VILLAGE OF LOMBARD
REQUEST FOR BOARD OF TRUSTEES ACTION
For Inclusion on Board Agenda

TO: VILLAGE PRESIDENT AND BOARD OF TRUSTEES
FROM: Scott Niehaus, Village Manager
DATE: February 22, 2021 (B of T) **Date:** March 18, 2021
TITLE: Amendment to Village Board Policy 6.C. – Street Lighting Policy
SUBMITTED BY: Carl S. Goldsmith, Director of Public Works

SUBJECT: Amendments to Village Board Policy 6.C. - Village Standard Lighting Policy

Village Standard Lighting

Arterial Light Pole

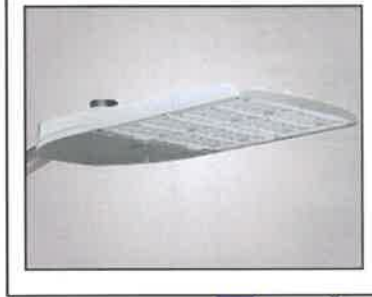
- The Village has amended the specification for arterial roadways. The current standard provides for three specifications for roadway lighting; (1) decorative poles such as those found on Main Street, (2) spun aluminum poles and (3) square steel poles ("shoebox"). The proposed change to the VSL would eliminate the square steel poles. These poles are prone to rust and are significantly more expensive. The cost of the square pole is approximately \$7,500 and the cost of the spun aluminum pole is \$2,000. The Village currently has 140 shoebox lights along St. Charles Road and Westmore Road.

- The Village has identified specific manufactures for the spun aluminum poles. Prior VSLs stated that poles would meet IDOT standards. These specifications have been added to the document.

Downtown The Central Business District Roadway
Steel Flared Base Poles

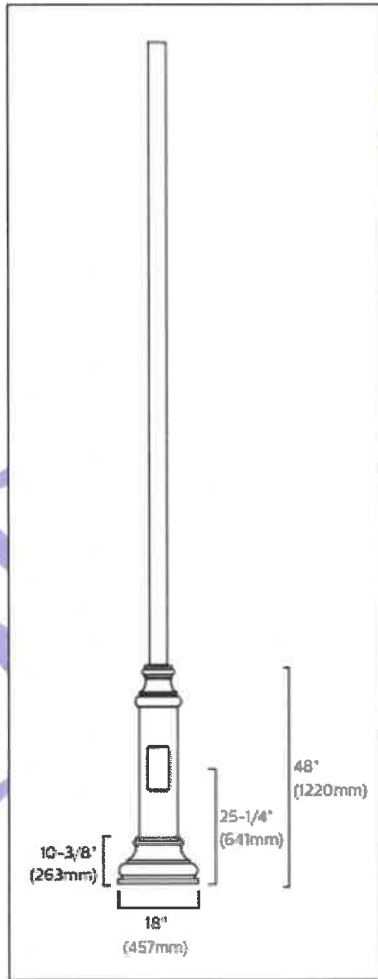
- With the Downtown TIF set to expire in 2023, the staff has amended language referring to the lighting in the downtown area to Central Business District. The concern is that over time, the term Downtown TIF may not be commonly understood to represent the St. Charles Road Corridor.
